CCK-2665-23

ADDENDUM# 1

### **ADDENDUM NUMBER ONE**

**UK Chemistry Physics Heat Exchanger  
ADDENDUM # 1- MEP                      10/13/2022**

**Item #3** Refer to Mechanical Drawing M2.1

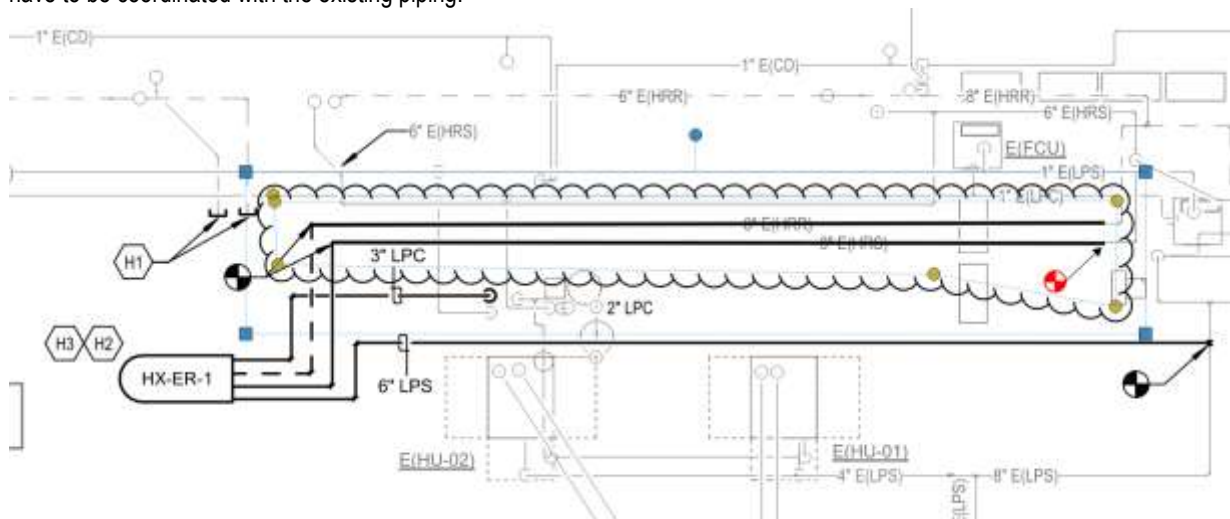
- A. Install new 8 inch piping to connect into where it is 8 inches existing. Demolish the run of 6 inch piping located in this same location. See sketch below for location.
- B. Remove existing abandoned RO water booster pump that is located next to where the new heat exchanger is located. Cut and cap existing 1 inch piping. Disconnect power source and turn the pump over to the Owner.
- C. Existing 2 inch condensate line is located under the proposed location of the heat exchanger. It may remain as located or the Contractor may offset the piping around the heat exchanger if they choose. If it remains, the heat exchanger support and piping will have to be coordinated with the existing piping.
